**City of Charlottesville
Board of Architectural Review
December 21, 2021**

Preliminary Discussion

540 Park Street, TMP 520183000

Project: Alteration, rear addition, and new pool house

Pool House

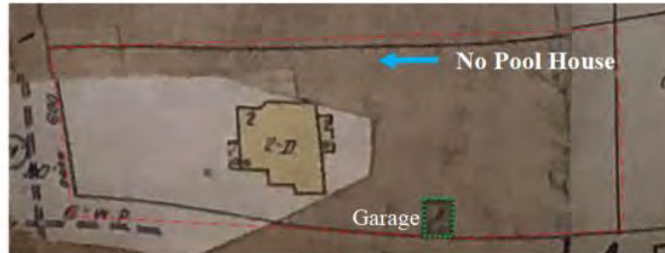
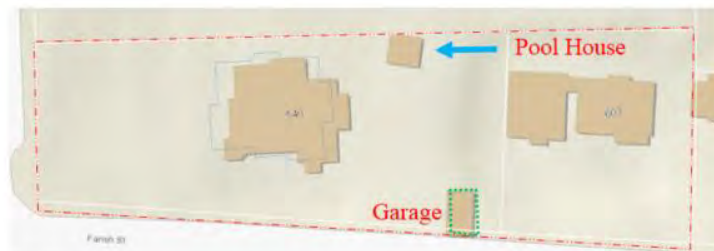
Re: razing the existing pool house: The pool house was constructed between 2000 and 2002. (See Appendix.) Staff is uncertain why it was designated a contributing structure. While a formal review will require compliance with Code section 34-2779(a), there is nothing to indicate this structure is historic or that its demolition would negatively impact the character of the ADC District. (Per 34-277(a), a CoA is required for the demolition of a contributing structure.)
